Centennial Coal

RESPONSE TO SUBMISSIONS

Airly Mine Extension Project

State Significant Development 5581

Figure 1 Modelled groundwater inflows into the mine workings under proposed conditions

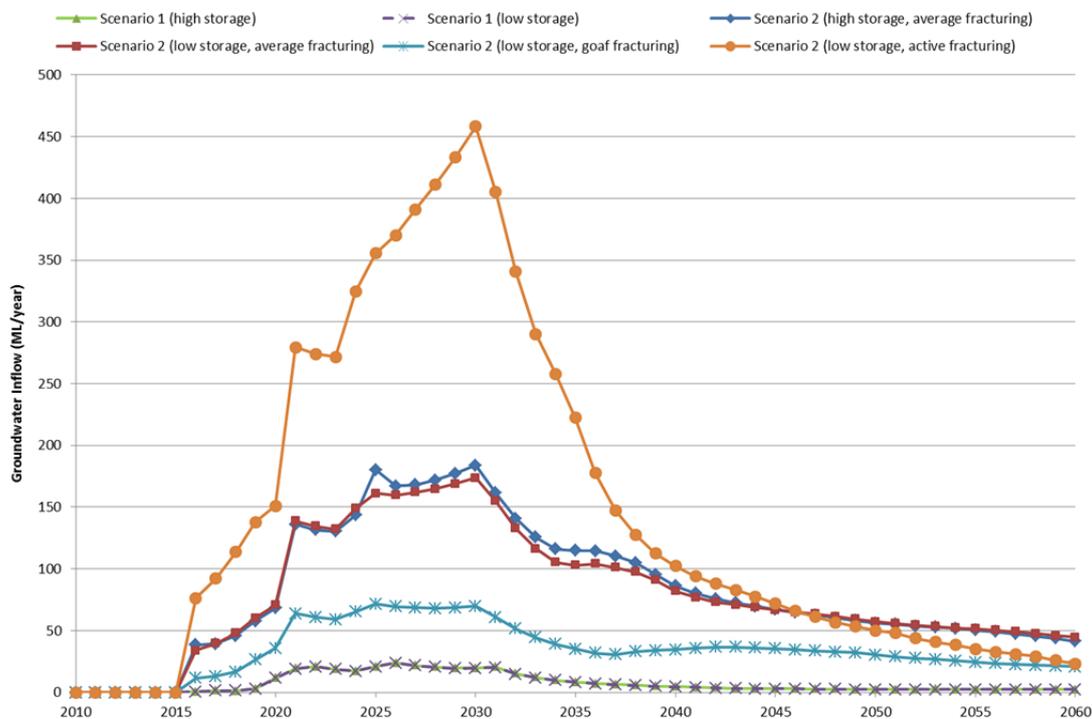
Since the ‘goaf’ fracturing phase is representative of hydraulic conductivities throughout the fracture zone throughout the majority of mine life, it is considered appropriate to apply these conditions within the hydrogeological model. However, to make the predictions more conservative an ‘average’ fracturing scenario was adopted based on the average hydraulic conductivity values of the ‘active’ and ‘goaf’ phases.

The highest predicted groundwater inflows occur when hydraulic conductivity values for the ‘active’ fracturing phase are adopted throughout the entire life of mine. However, these inflows are considered to

be unrealistic since this phase occurs for less than two months following panel extraction and therefore was not considered further in the groundwater impact assessment or water balance assessment. The next highest groundwater inflows occur when 'average' fracturing parameters are adopted. These inflows exceed those predicted when hydraulic conductivity values for the 'goaf' fracturing phase are adopted throughout the entire life of mine (as shown in Figure 1) and were therefore considered to be conservative (but not unrealistic) and were assessed in the groundwater impact assessment (GHD, 2014d) and water balance assessment (GHD, 2014a).

**Figure 4.1:
Proposed
Mining Zones**

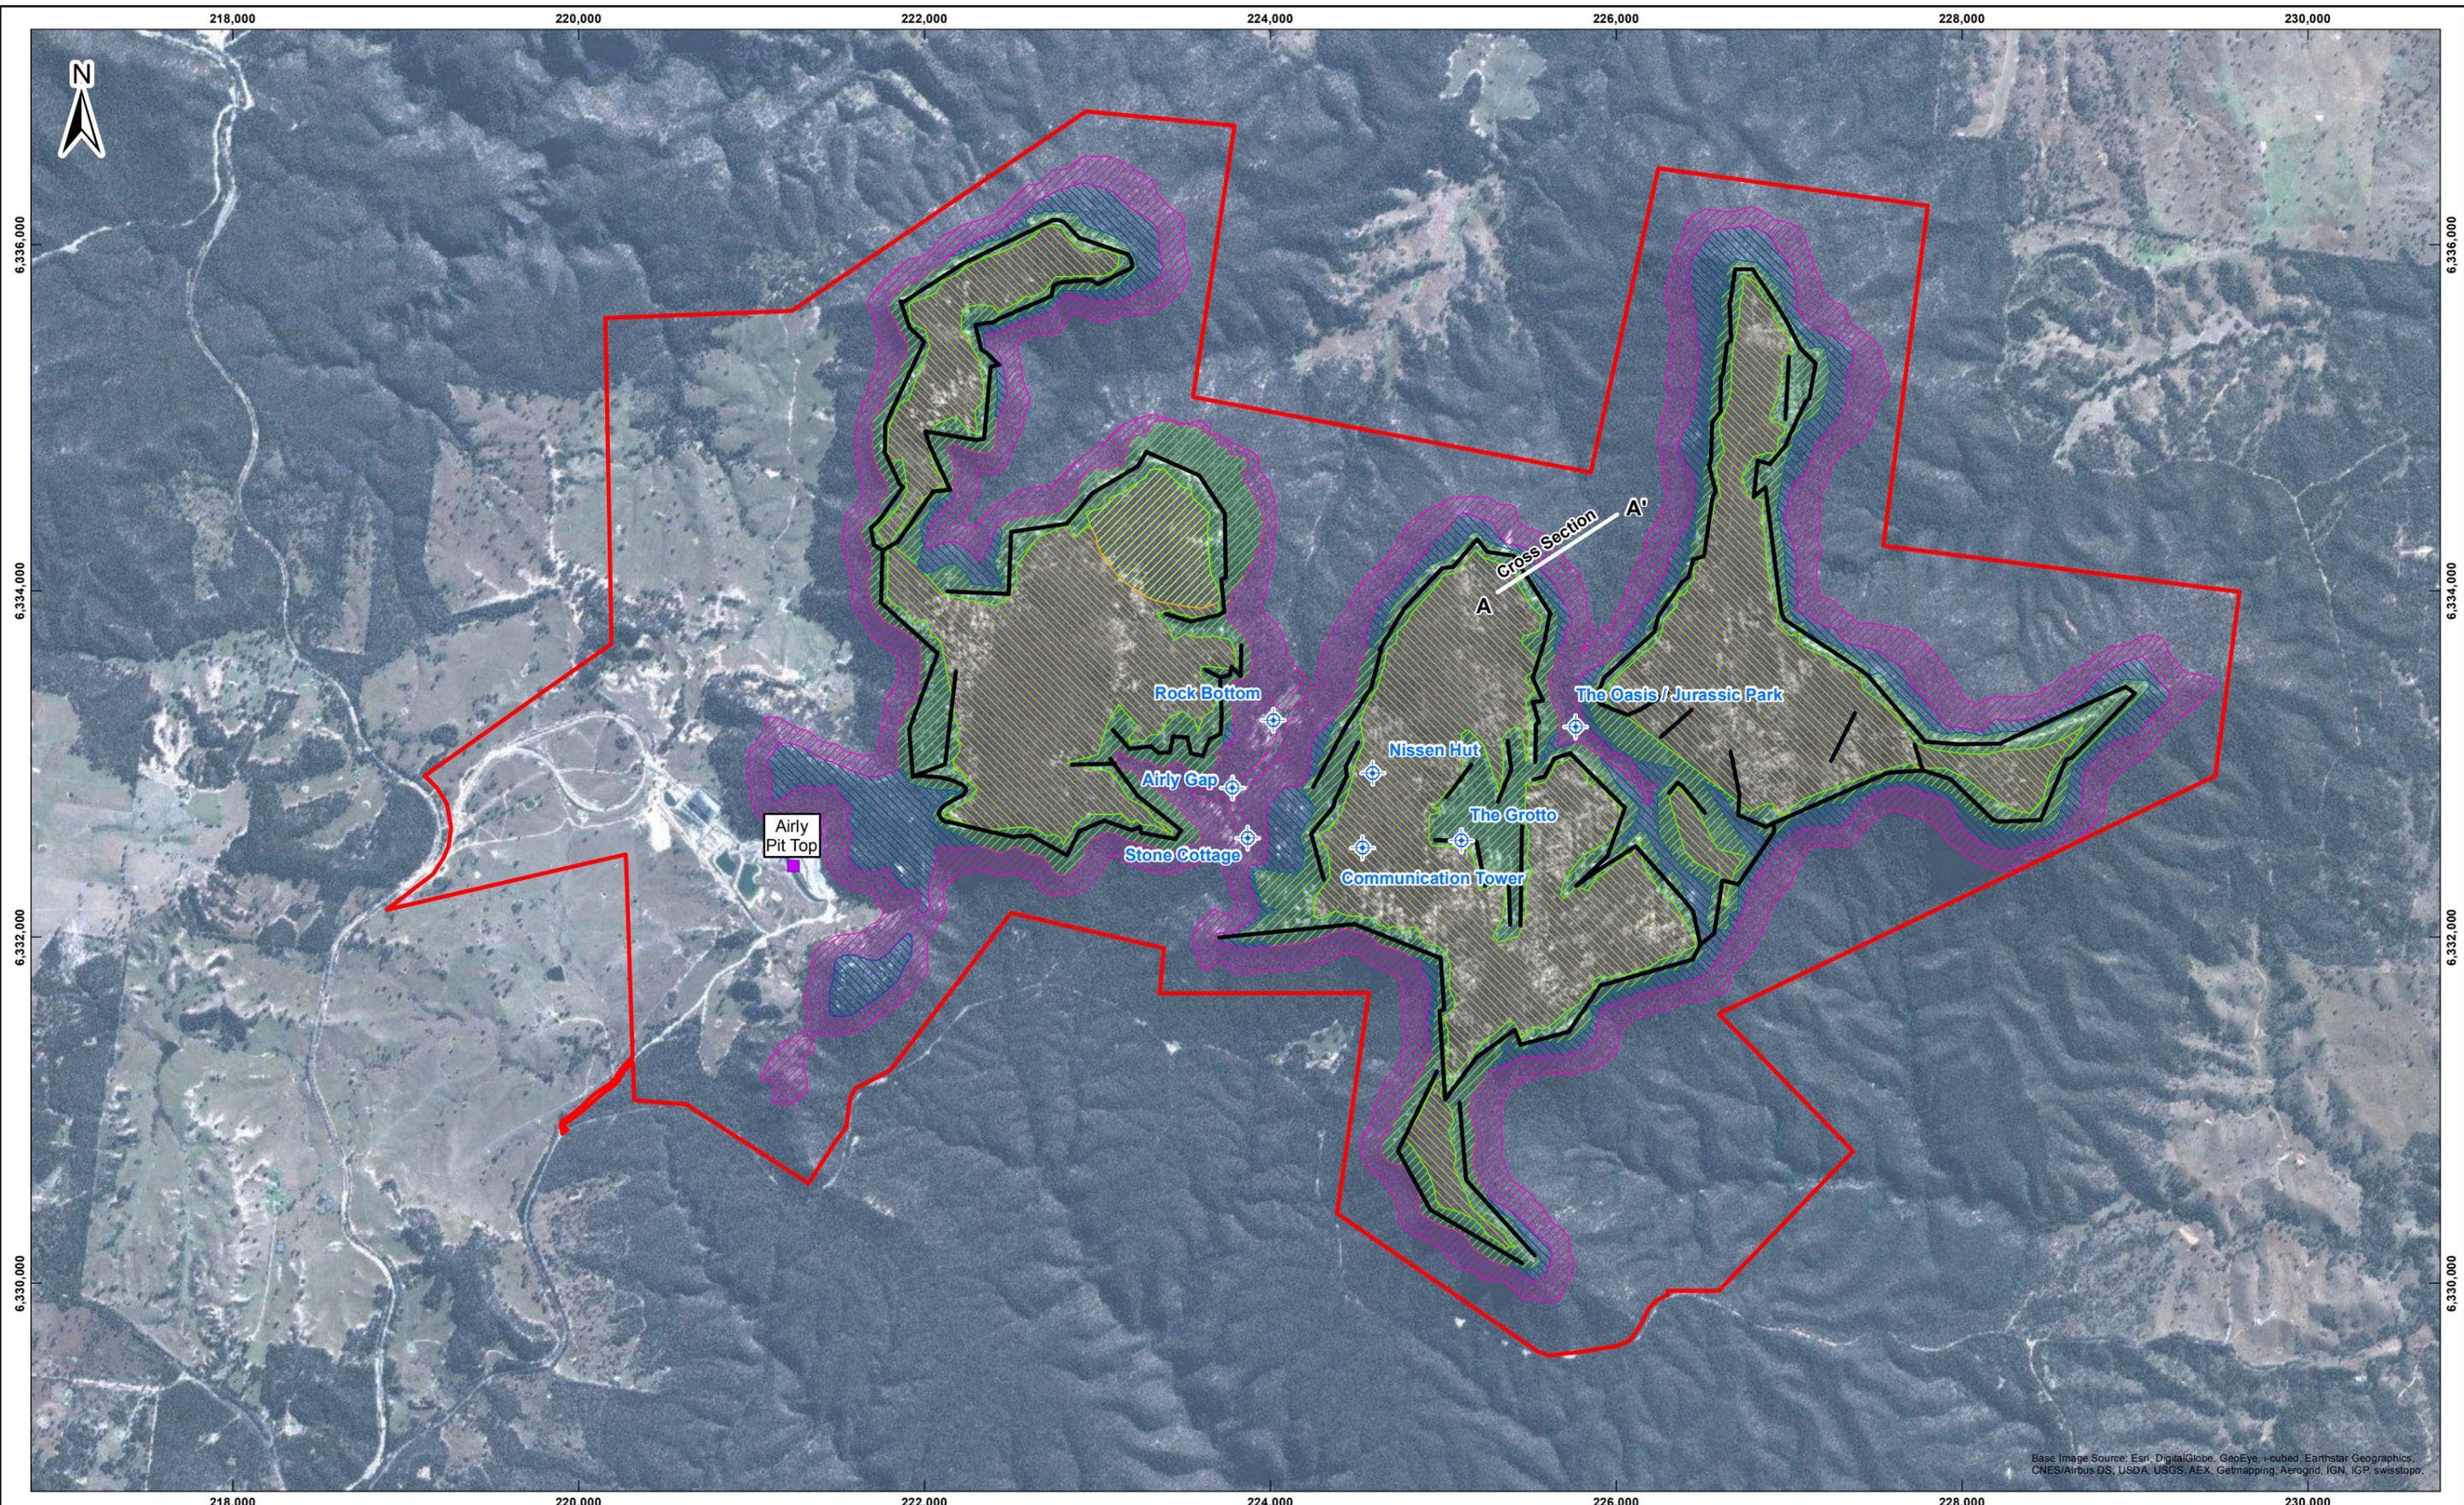
A review of the EIS has revealed that there is an inconsistency between the proposed mining zones presented in the EIS Figures 4.1, 8.2 and 8.9 with those presented in the Subsidence Impact Assessment (Golder Associates, 2014) and technical assessments. The mining zones presented (and assessed) in Golder Associates (2014) are correct. Similarly, the mining zones presented in majority of the technical assessments (except the Aquatic Ecology and Stygofauna Impact Assessment (Cardno, 2014)) are correct. Figure 6.1 in Cardno (2014) shows the incorrect mining zones. Section 6.2.2.2 of Cardno (2014) has referred to this Figure 6.1, however, the mitigation measures proposed in the section has relied on the impact assessment discussions in the Subsidence Impact Assessment. Centennial Airly can confirm that impact assessments have been undertaken for the correct mining zone boundaries in all relevant technical assessments and no further impact assessments are required.

The EIS Figures 4.1, 8.2 and 8.9 and Figure 6.1 in Cardno (2014) have been updated and are included in **Appendix G** of the RTS.

Figures 4.1, 8.2 and 8.9 presented in the EIS and Figure 6.1 in Cardno (2014) represent the initial mining zones proposed in the early stages of the EIS preparation. Following an assessment of the impact of post mining flooding (GHD (2014a)) on the associated extracted workings required a reduction in the area of the deposit suitable for partial pillar extraction, as shown in the revised figures included in **Appendix G**. The reduction in the Partial Pillar Extraction Zone (and the resulting increase in the Shallow Zone) was necessary as the post-mining flooding study was showing subsidence results to be outside the proposed design limits. The expansion of the Shallow Zone with proposed first workings with splitting and quartering has the same extraction rate of 52% (refer Section 5.3.1)) and has a lower level of subsidence than that proposed for the partial pillar extraction.
